Title: **STAGE 1&2 ROAD SAFETY AUDIT**

Proposed Residential Development at Mill Lane, Leixlip.

Client: **Pinnacle Consulting Engineers on behalf of Clúid Housing**

Report reference: **2058R01- Rev 1**

Drawing P230400419-PIN-XX-XX-DR-D-101-SI Rev P04, Mill Lane junction visibility.

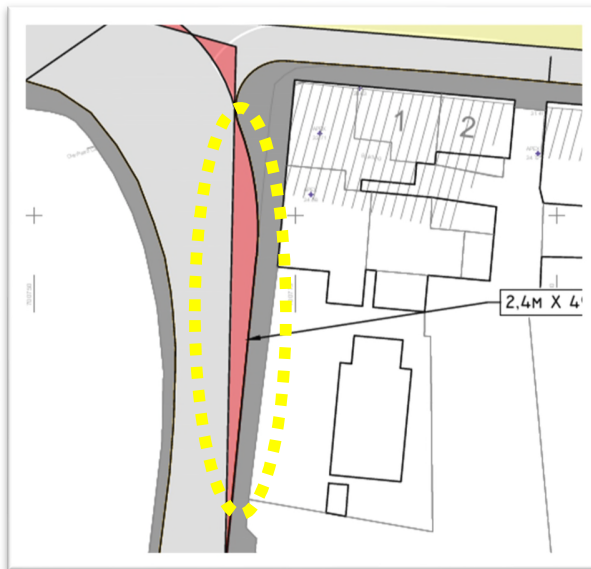
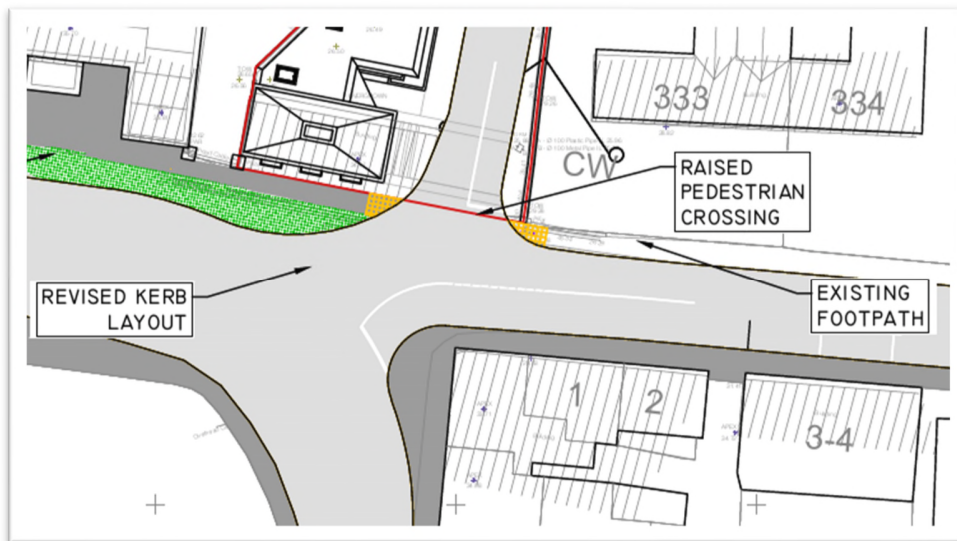
The drawing shows the visibility to the left for drivers exiting Mill Lane onto Main Street. There is a risk that parked vehicles will obscure the sightline resulting in side-impact or rear-end collisions.

It is recommended that parking be prohibited or that the visibility splay take into account any proposed parking arrangements.

Drawing P230400419-PIN-XX-XX-DR-D-101-SI Rev P04, Mill Lane junction, Pedestrian desire line.

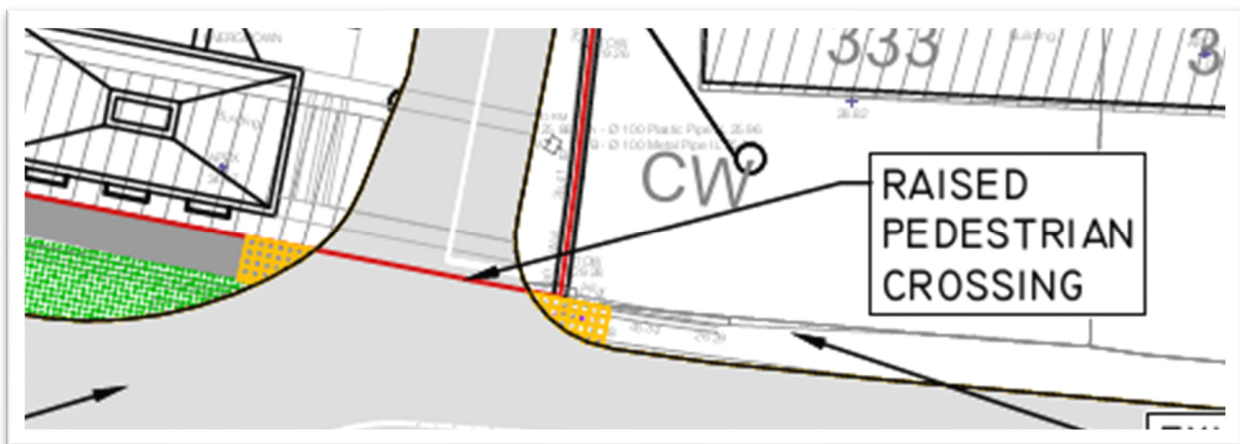
There will be a pedestrian desire line to cross the Mill Lane junction with Main Street. Without adequate crossing facilities there could be trips and falls on the high kerbs or slips on the landscaped area.

It is recommended that a crossing be provided along the desire line.

A crossing has been provided in the July 2025 update – This problem is therefore resolved.

Drawing P230400419-PIN-XX-XX-DR-D-101-SI Rev P04, Mill Lane junction, Access junction.

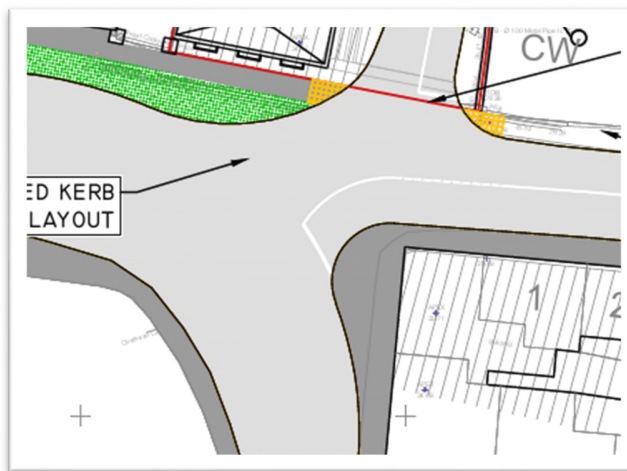
The drawing indicates a raised pedestrian crossing at the access junction into the development. There is a risk that given the fixed footpath location that to raise the crossing would lead to a steep taper which could result in grounding of vehicles or a narrow crossing point which could lead to inaccessibility for some pedestrians and loss of balance/falls on the steep crossfall of the taper.

It is recommended an at-grade crossing be provided with additional warning for drivers of the need to stop by providing STOP road marking text and a stop sign.

[This issue has been resolved in the 2025 update.](#)

Drawing P230400419-PIN-XX-XX-DR-D-101-SI Rev P04, Main Street, yellow box.

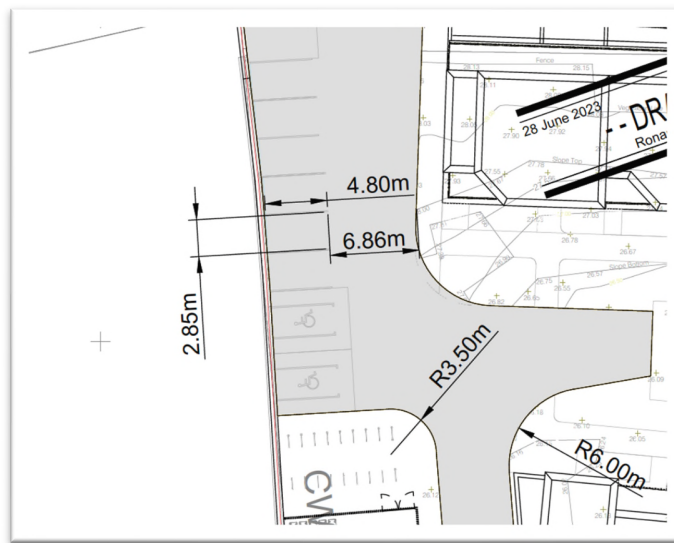
It is unclear if the existing yellow box on Main Street is to be retained. Without this yellow box drivers may not get much opportunity to exit from Mill Lane given how busy Main Street is. This could result in drivers attempting to take small gaps in traffic leading to side-impact or rear-end collisions.

It is recommended that the yellow box (and high friction surfacing) be retained.

The Yellow box is shown to be retained. It is unclear if the high friction surfacing is to be retained.
